Access Compliance Report

Public Rights-of-Way

(Curb Ramps)

Intersection ID: 14937	Main Street: BRIGHTON_PL	Cross Street: NORLAND_RD	Location: W
ADA ID: 825495F2420E	Ramp Type: Perp	Initial Pass/Fail: Fail	Overall Compliance: No
Severity Score: 13.75			
Codes/Mitigation Info/Possible Solution		Field Measurements/Component Compliance

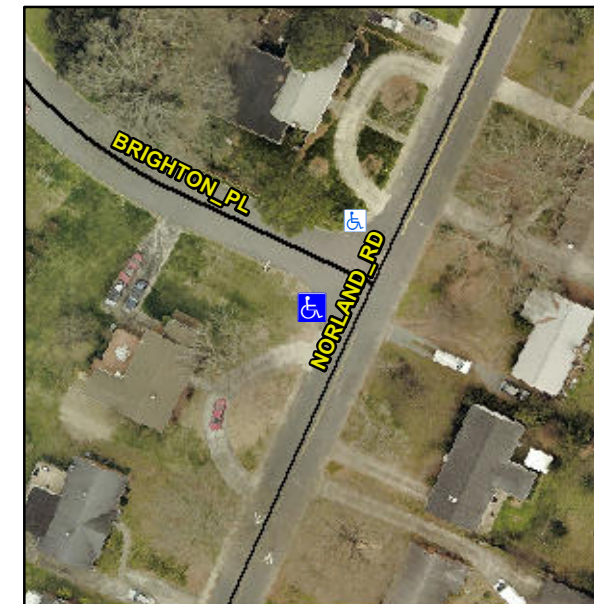
R304.2.2, R304.5.3

Compliance	Description	Data	Compliance	Description	Data
N/A	Ramp Length (in)	47.5	No	Ramp Slope (%)	8.6
Yes	Ramp Width (in)	48.0	No	Ramp XSlope (%)	2.9
N/A	Flare Type LT	N/A	N/A	Flare Type RT	N/A
N/A	Flare Slope LT (%)	N/A	N/A	Flare Slope RT (%)	N/A
N/A	Flare Traversable LT?	N/A	N/A	Flare Traversable RT?	N/A
N/A	Landing Length (in)	N/A	N/A	DWS Provided?	N/A
N/A	Landing Width (in)	N/A	N/A	DWS Contrast?	N/A
N/A	Landing Slope (%)	N/A	N/A	DWS Length (in)	N/A
N/A	Landing X Slope (%)	N/A	N/A	DWS Full Width?	N/A
N/A	Landing Curb? (Y/N)	N/A	N/A	DWS Offset (in)	N/A
N/A	Shared Landing?	N/A			
N/A	Gutter Ponding?	N/A	N/A	Gutter Slope (%)	N/A
N/A	Gutter Lip Ht (in)	0.5	N/A	Gutter X Slope (%)	N/A
N/A	Painted X Walk1?	No	N/A	Painted X Walk2?	N/A
	X Walk 1 Direction	To NE		X Walk 2 Direction	N/A
N/A	X Walk 1 Width (in)	N/A	N/A	X Walk 2 Width (in)	N/A
	X Walk 1 Slope (%)	2.8		X Walk 2 Slope (%)	N/A
	X Walk 1 X Slope (%)	7.1		X Walk 2 X Slope (%)	N/A

Remove & Replace Entire Ramp.
